Model: SP3		Date: 30-Sep-97	No: 1
Subject: SCU ROM Modification		Prepared by: A.Tokoyama	
From: QAC 2nd Field Information Dept.			
Classification:	<input type="checkbox"/> Troubleshooting	<input checked="" type="checkbox"/> Part information	<input type="checkbox"/> Action required
	<input type="checkbox"/> Mechanical	<input type="checkbox"/> Electrical	<input type="checkbox"/> Service manual revision
	<input type="checkbox"/> Paper path	<input type="checkbox"/> Transmit/receive	<input type="checkbox"/> Retrofit information
	<input type="checkbox"/> Other ()

Model: Finisher for SP3		Date: 30-Sep-97	No: 2
Subject: SC101		Prepared by: E.Fukuyama	
From: QAC 2nd Field Information Dept.			
Classification:	<input checked="" type="checkbox"/> Troubleshooting	<input type="checkbox"/> Part information	<input type="checkbox"/> Action required
	<input type="checkbox"/> Mechanical	<input type="checkbox"/> Electrical	<input type="checkbox"/> Service manual revision
	<input type="checkbox"/> Paper path	<input type="checkbox"/> Transmit/receive	<input type="checkbox"/> Retrofit information
	<input type="checkbox"/> Other ()

Model: SP3		Date: 15-Apr-98	No: 14
Subject: Duplex Jam		Prepared by: A.S

Entrance Guide Installation Procedure

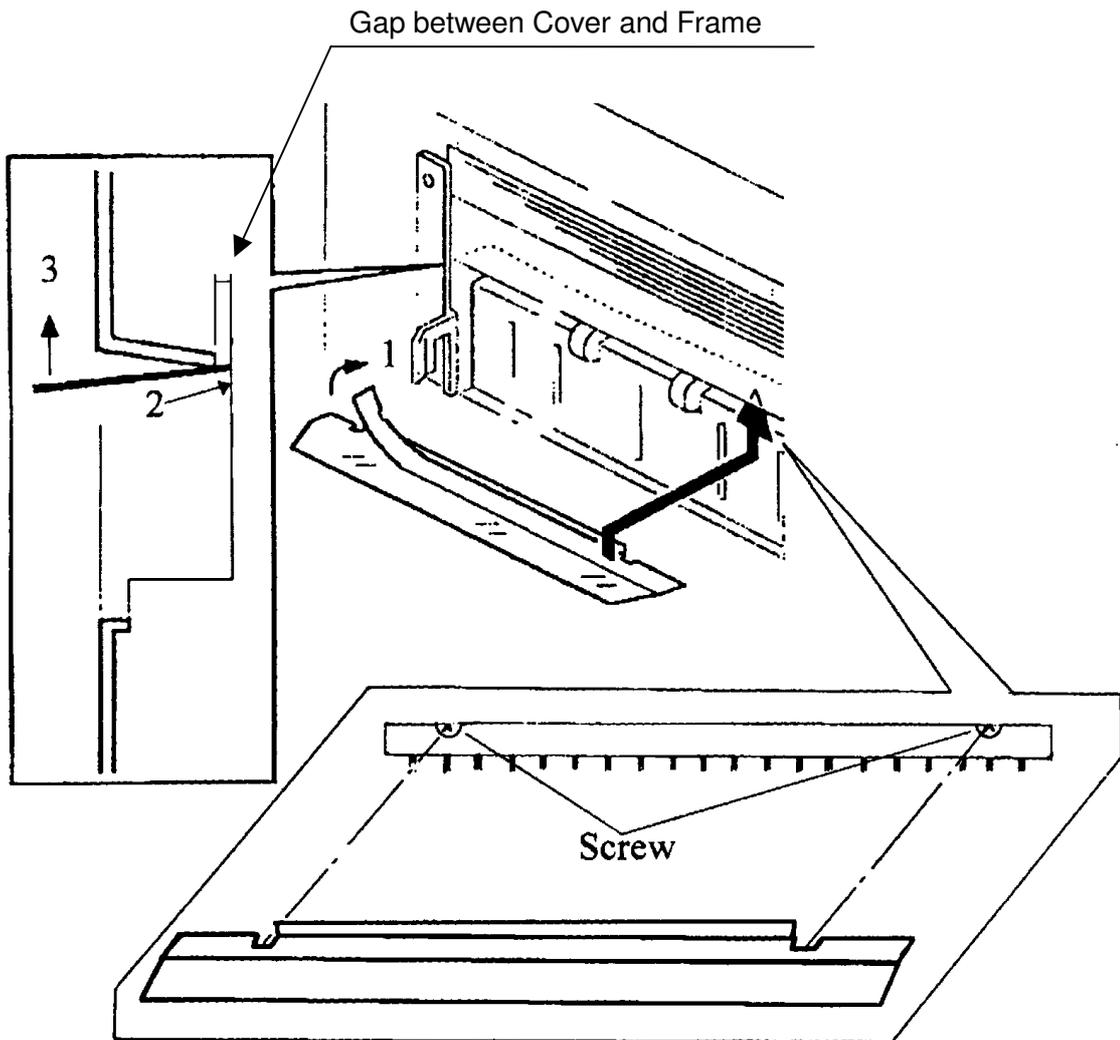
If the Entrance Guide is not installed in the proper position, a gap may develop between the Cover and the Main Frame through which the heat and humidity generated by the paper may enter and lead to high temperature/high humidity around the lamp stabilizer.

During the set-up of a Finisher manufactured after May 1997, please install the Entrance Guide in a manner that will prevent a gap from developing between the Cover and the Main Frame. Please refer to the attached page for this procedure.

1. Peel off the tape seal for the Entrance Guide
2. Place the Entrance Guide on the Main Frame.
3. Attach the Entrance Guide to the Cover

New Entrance Guide

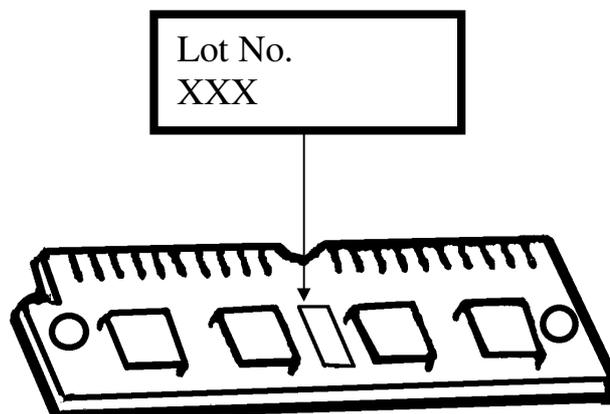
1. At installation, the PS2 board cannot be recognized.
2. New PS software cannot be reprogrammed into the PS2 board, because it is not possible to erase the programmed software before reprogramming it.

1. The program in some PS2 options was damaged due to noise on the cable between the PC and the checker in the factory which downloads the software.
2. The PS2 option uses flash ROMs from two vendors (Fujitsu and AMD). The AMD chips were used for the December production in 1997 and January production in 1998. These chips cannot be erased before programming new software.

- A. Stocked PS2 options in the warehouse
Please replace them with new ones and send back the old ones.
- B. PS2 options in the field
1. When the PS2 board cannot be recognized after installing it, please replace it with a new one.
(Note) Before replacing it, please reinstall again and confirm that it can be recognized.
 2. Please replace all boards with the lot no. of 7Zxxx and 81xxx with new ones.
The lot no. is shown on the carton or on the label on the board as shown below.

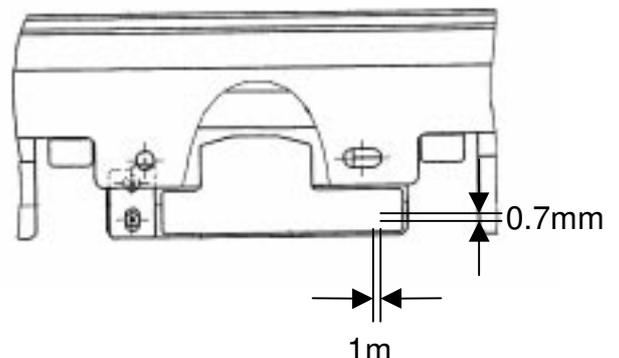
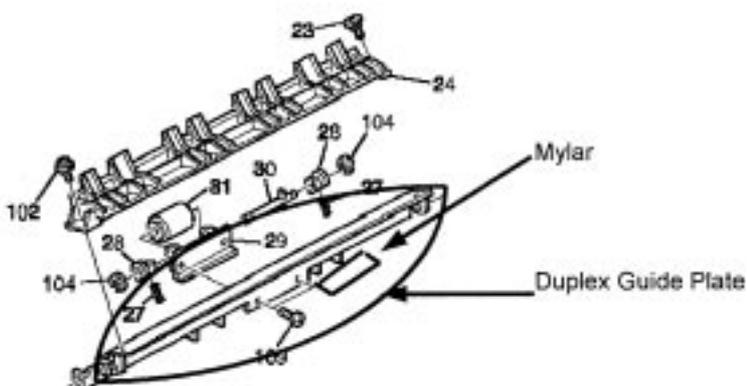
1. During paper feed from the duplex unit, the leading edge of the paper is bent or a no-feed jam occurs.
2. During stacking in the duplex unit, a stacking jam occurs.

1. Paper feed jam (leading edge bent or non-feed)
 - 1) Check to see if the duplex guide mylar is set properly. If it is bent or out of position, please replace ***the duplex guide mylar (A1344670)*** or the duplex guide plate ***(A1344662)***.

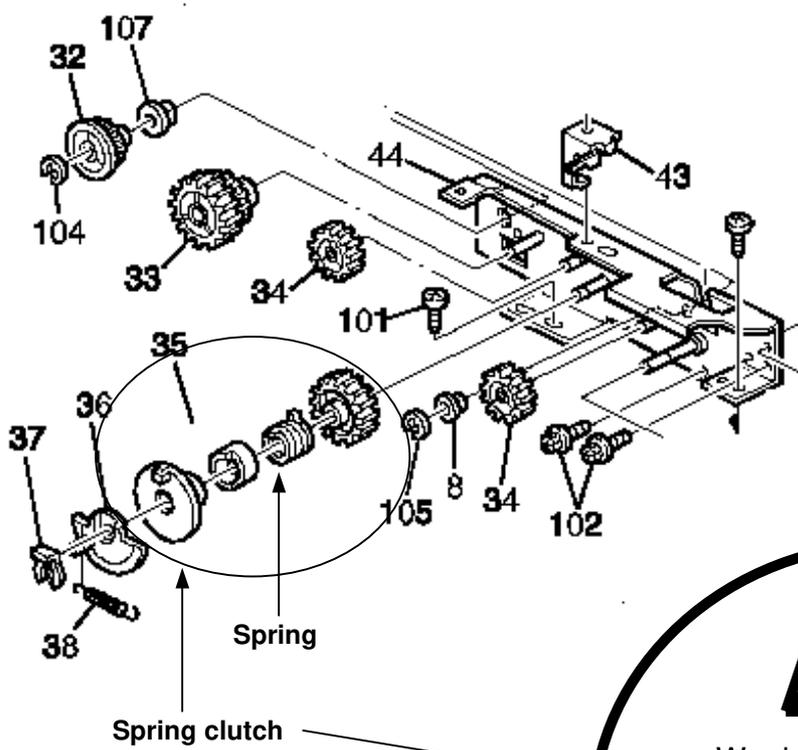
(If the mylar is bent or out of position, the leading edge of the copy may be bent or no-feed jams may occur.)

Reattaching the mylar (as shown below) is a temporary countermeasure. As a permanent countermeasure, the duplex guide plate should be replaced.

Spring clutch as viewed from the rear of the unit

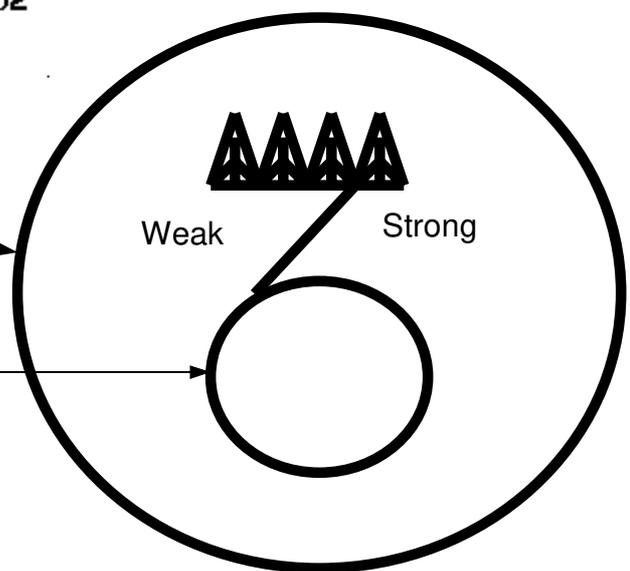
- 2) If 1) does not solve the problem, change the position of the spring in the spring clutch to increase the pressure on the bottom plate, or replace the spring clutch.
 - By adjusting the spring setting, the pressure on the bottom plate in the duplex unit increases. The stronger it is set, the more effective it is. (If the pressure on the bottom plate is insufficient, no-feed paper jams may occur.)

There are 3 settings for the spring. The one on the right is the strongest.

- 3) If 2) does not solve the problem, change the spring clutch (P/N AB040015) to a modified one (P/N AB040017). (Refer to an MB for the details of the modification.)

2. Stacking Jams

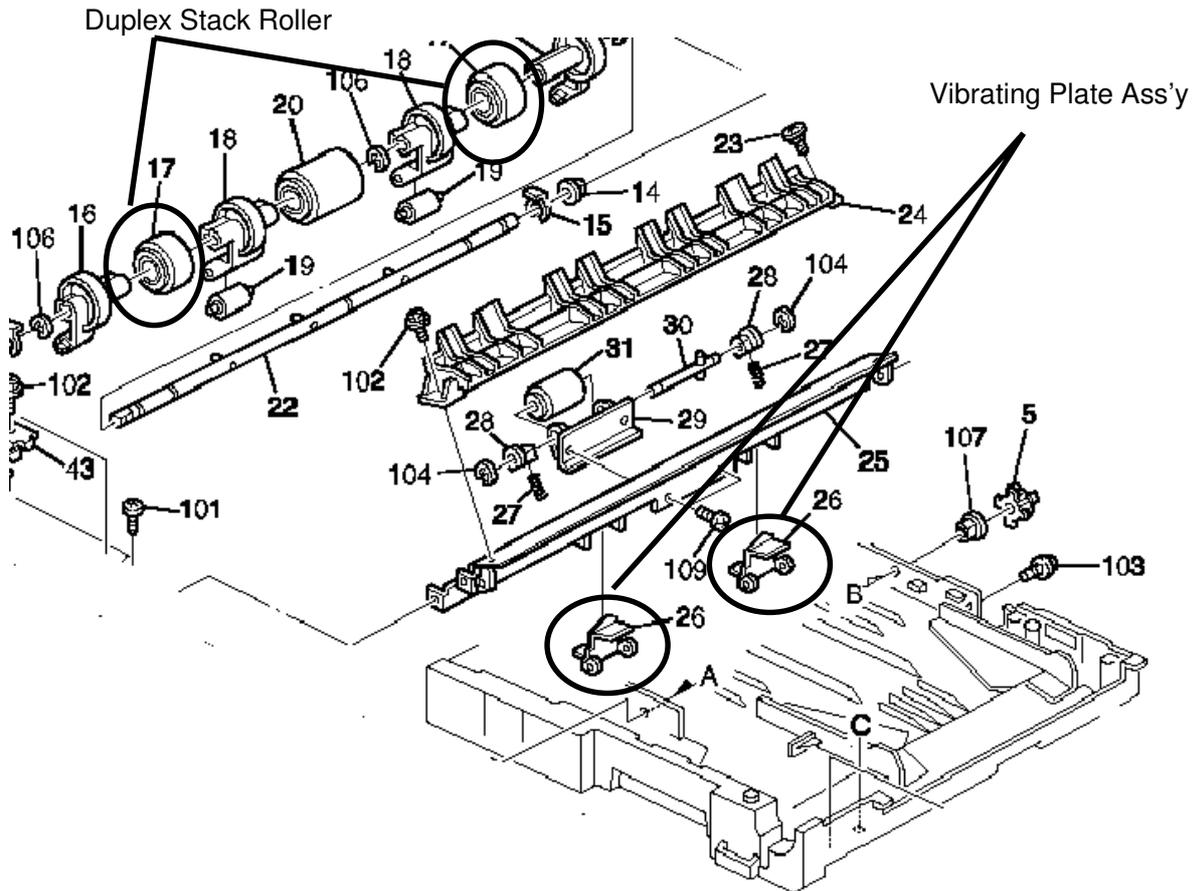
- 1) Check the condition of the mylar setting on the vibrating plate ass'y. If it is bent or damaged, replace the vibrating plate ass'y (A1544626)
 Rotate the duplex stack roller. If it makes a clicking sound, it is OK.
 (If the mylar is bent or damaged, stack jams may occur.)

- Duplex Jam indicated = OK -

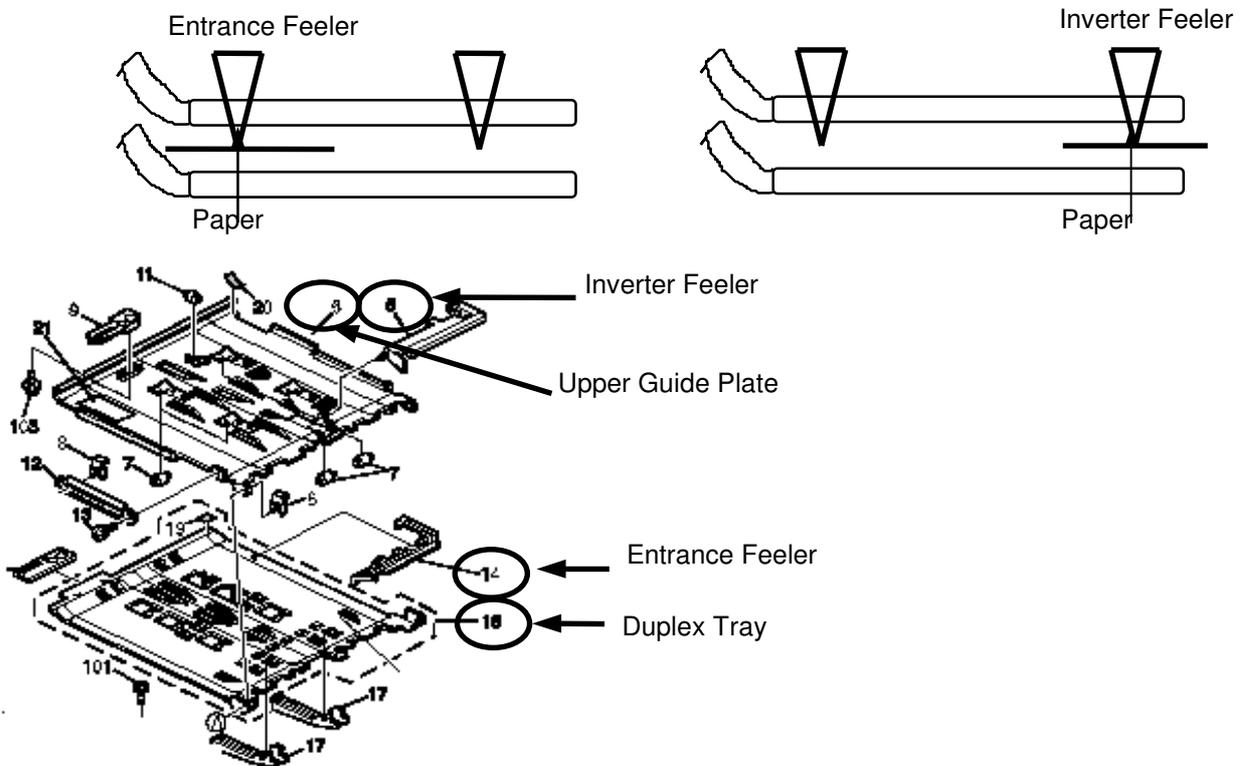
Check procedures: Pull out the duplex unit and put paper in between the upper guide plate and the duplex tray as shown below. Next, insert the tray and note whether or not a duplex jam is indicated. If it is, then it's OK. (This checks the inverter feeler detector and the entrance feeler detector.)

- Please inform the users that they should pull out the duplex unit all the way when removing paper when a jam occurs. If the duplex unit is only pulled out part way, this may lead to deformation of the upper guide plate and the duplex tray.

2) Check to see if the upper guide plate (A13444732) or the duplex tray are deformed. If so, replace the parts.
